**Operator: CIVITAS NORTH LLC**  
**Location Name: Canvasback Pad**  
**Loc ID: 461821**  
**Inspection: 708200674**

**Exhibit A**

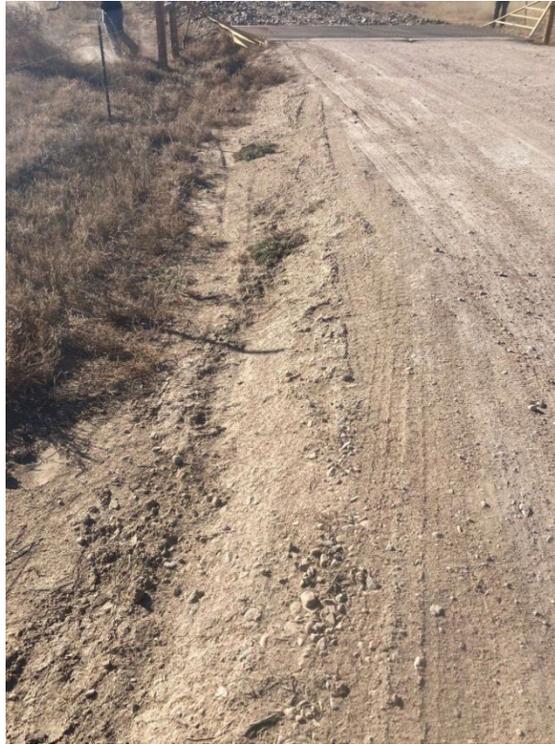
**CA:** Previous inspection (doc #708200165) noted trash throughout the location. Operator submitted FIRR (doc #403395809) and provided photo documentation that trash had been removed. However, during this inspection, significant trash was observed throughout the location, including outside of the disturbance areas (e.g. off location). Refer to attached inspection photos for examples. Comply with Rule 606 and remove all trash, including any trash that has blown off location. The location will remain out of compliance until the corrective action has been resolved.

**CA Resolution:** Operator has addressed and cleared trash, debris and unused equipment/materials from location to comply with Rule 606.
